TITLE: SPECIAL PERMIT NO. 08018, requested by First Plymouth Congregational Church, to allow a parking lot in a residential zoning district; to waive the minimum 15 foot site penetration per Chapter 4.0 of the Lincoln Design Standards; to allow parking in the front yard along South 21st Street and F Street; and to allow for a sign in the front yard, on property generally located at South 21st Street and F Street.

LINCOLN CITY/LANCASTER COUNTY PLANNING STAFF REPORT

PROJECT #: Special Permit No. 08018

**RE: First Plymouth Congregation Church Special Permit Application for Parking Lot
21st & F Street, Lincoln, NE**

Site Demolition/Grading Plan

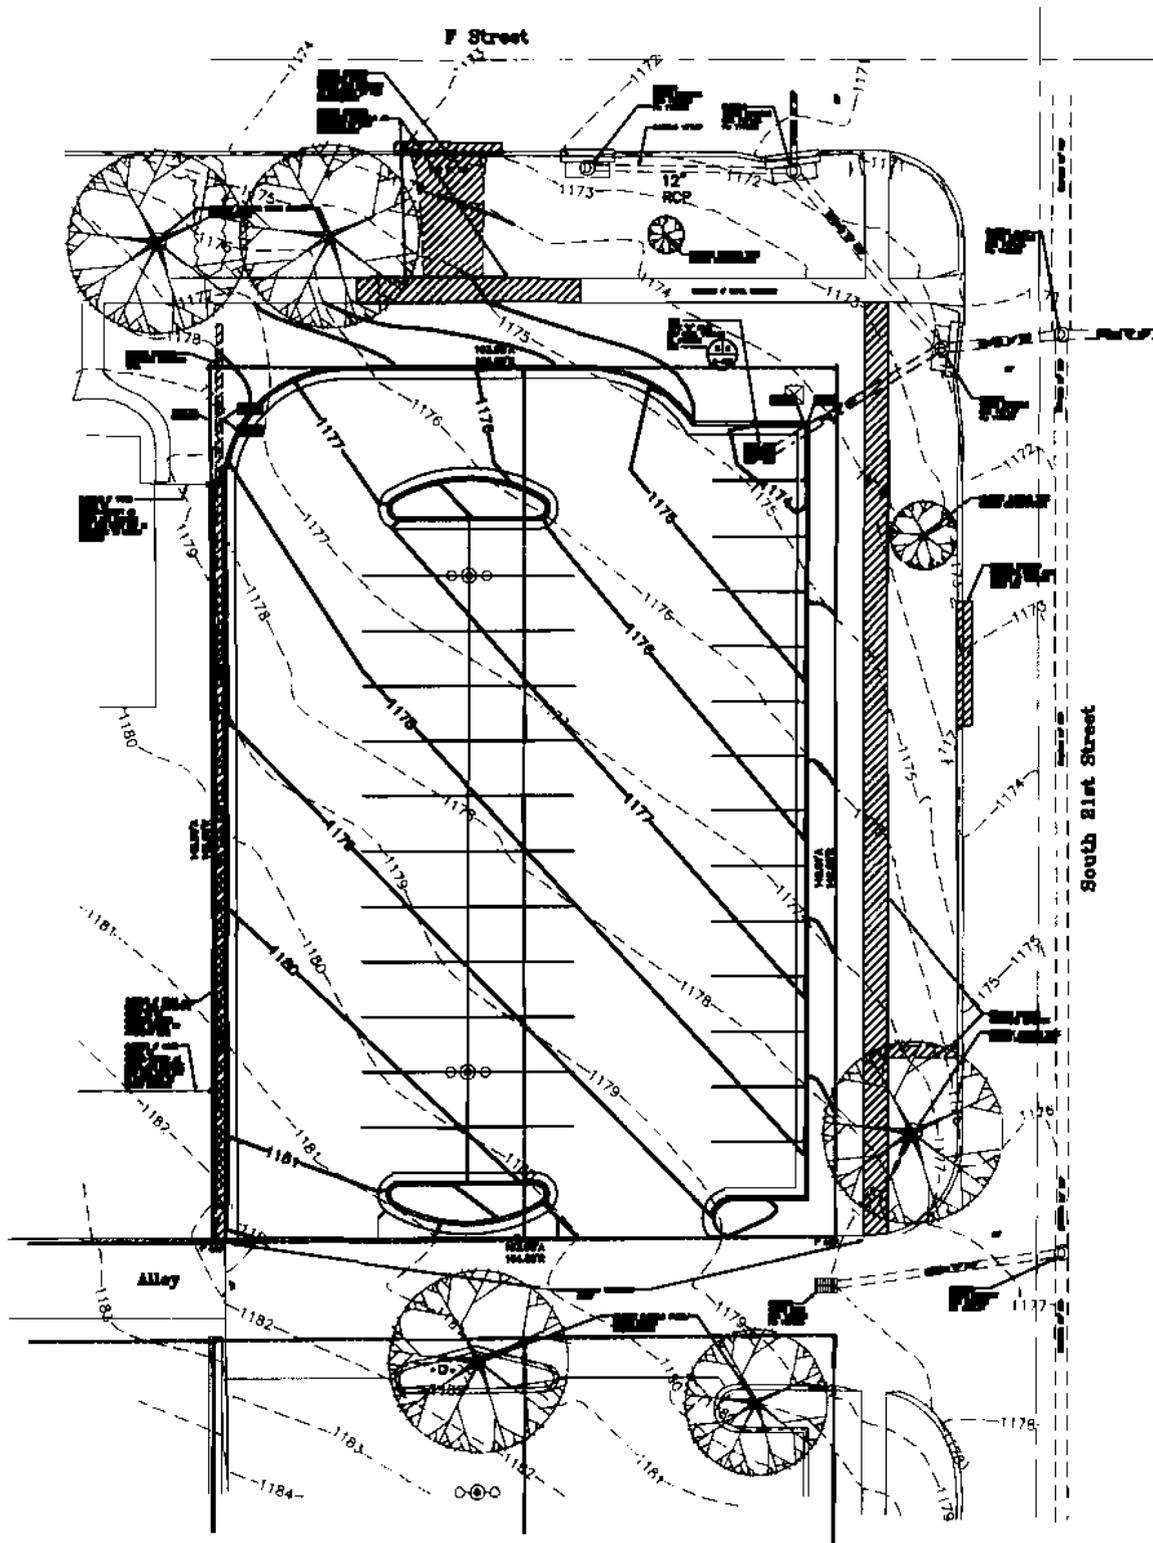
Dennis Bartels of Public Works explained that the conflict with the design standards is the three stalls that are within 6' of the alley. It is a public alley going the full block, paved from F Street west. The design standards provide that all maneuvering space must be on the permittee's property. The end

stalls cannot be entered without making a second maneuver, i.e. backing out into the public alley. Public Works has authority to waive the design standards, but Bartels does not believe that the applicant provided the necessary justification for this waiver. The only documentation provided was to maximize the number of stalls on a lot. He did not find that that was within the spirit of the design standards. Public Works is proposing an alternative layout with diagonal parking which provides a 13' aisle and keeps the 15' penetration clear. This would be two less stalls than shown on the applicant's plan. It also keeps the landscaping on private property.

• Ref 2. - The requested waiver of the 15' sight penetration distance does not apply to the "F" Street driveway because of the parking lot layout design. However it would apply to the 1st stall off the alley access from 21st Street. This waiver was not requested, and Public Works would not support the waiver and would require the adequate turning maneuver distance apply in the building permit review process.

- 1.1.2 Provide a minimum 15' site penetration for the 1st stall off the alley access from 21st Street or unless a waiver of the minimum site penetration requirement is obtained by the City Council.

**Site Landscaping Plan**

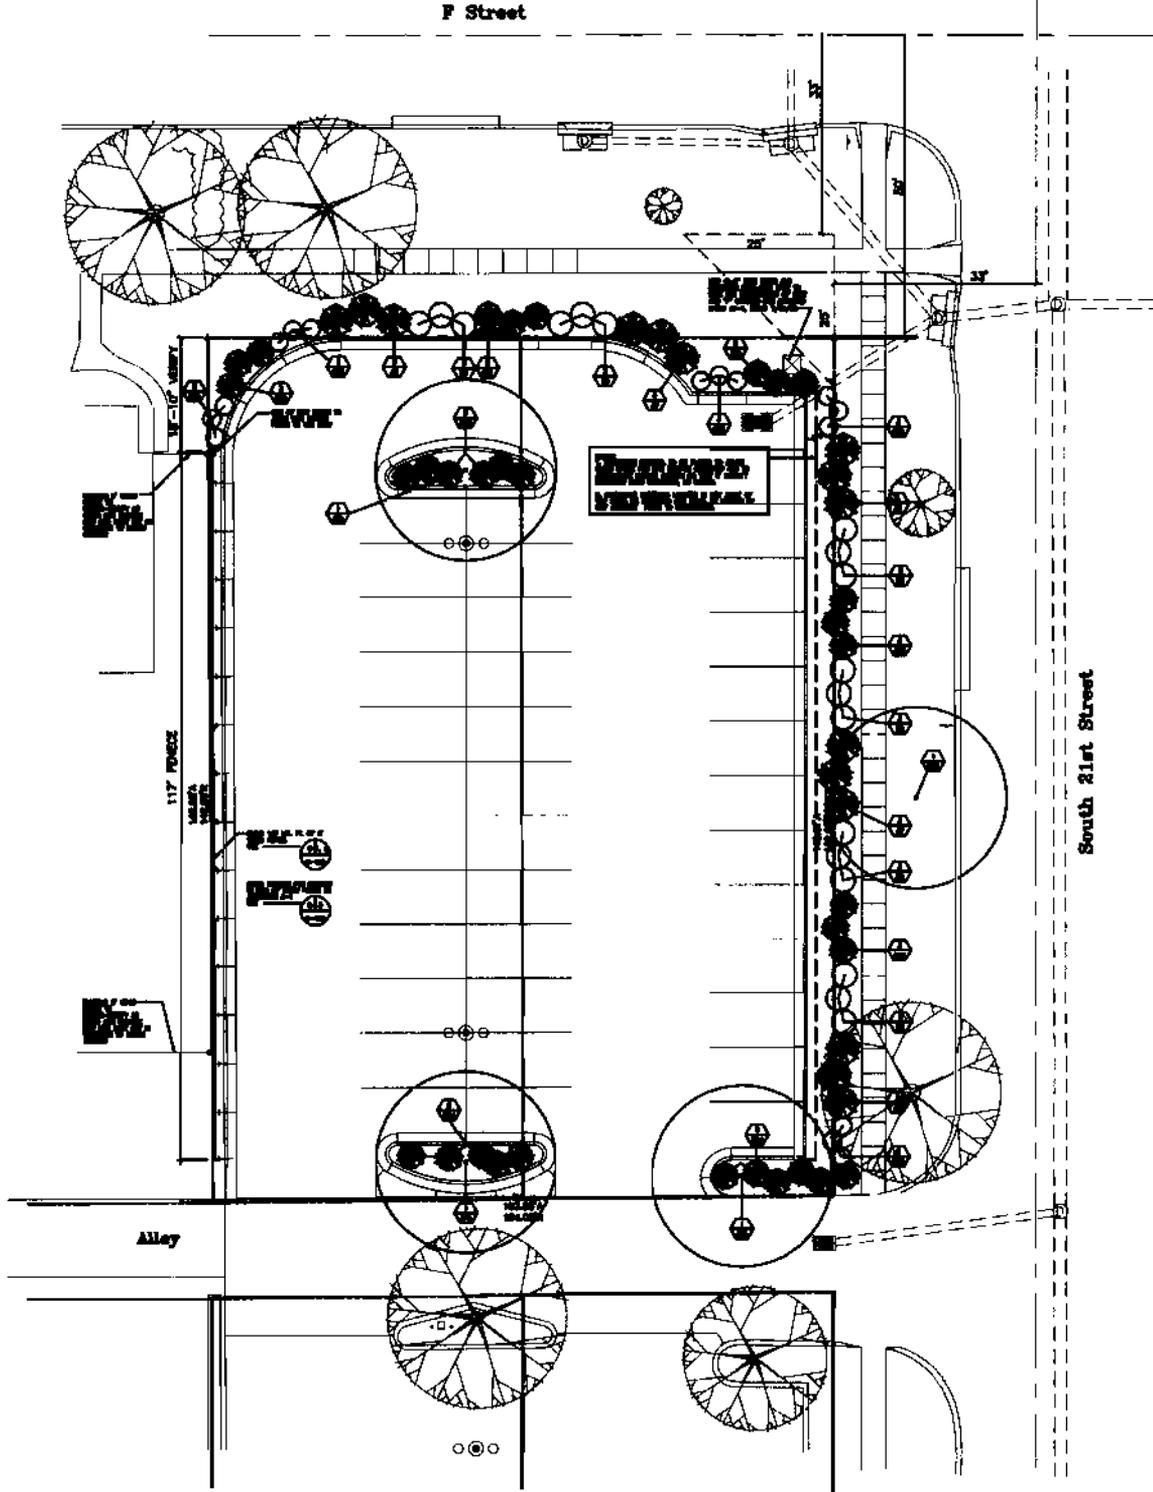
4. Placing the landscape screening in the public right-of-way is not generally recommended, per Chapter 3.50 of Lincoln Design Standards, and where there is space available for plants, they should be planted on private property. Screening is needed to reduce the impact on the neighborhood especially when parking is allowed in the front yard. Staff recommends approval of the waiver request and recommends a bond in an amount to guarantee the health and vitality of the landscape screen should be posted and a revised landscape plan shall be submitted meeting the satisfaction of the Director of Planning.

5. The applicant has agreed to increased screening. The design standard requires a minimum 90% screen from 0 to 3 feet. In this instance screening should be increased to

• Ref 1. - Public Works cannot recommend that the waiver to request that landscape screening material be allowed to be placed in the right-of-way be approved.

- 1.1.1 Submit a revised landscape plan showing an 100% screen from 0 to 3ft high along S. 21st Street and F Street (except in the sight triangle, where the screen will not exceed 30 inches in height) to be approved by the Planning Director. Screening shall meet all landscape design standards, unless City Council approves placing screening on street right-of-way.
